Door noise for all ovens with a pyrolysis function

New clasps

New reinforced clasp

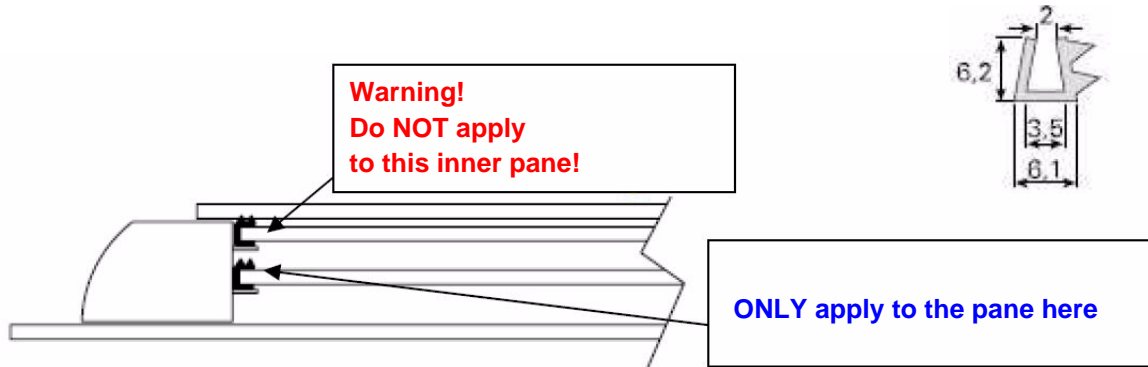
When the pyrolysis function is operating, the glass in the door expands. This needs to be taken into account when developing the holders.

These clasps allow the glass to move up to a certain point. When the door is closed a noise that the customer will hear is produced.

This part was improved in production up to January 2010 and reinforced so that the glass is held better. This reinforcement reduced the movement of the glass pane.

The plastic clasps are available under the following **spare-part numbers: 543597** (left) and **543596** (right).
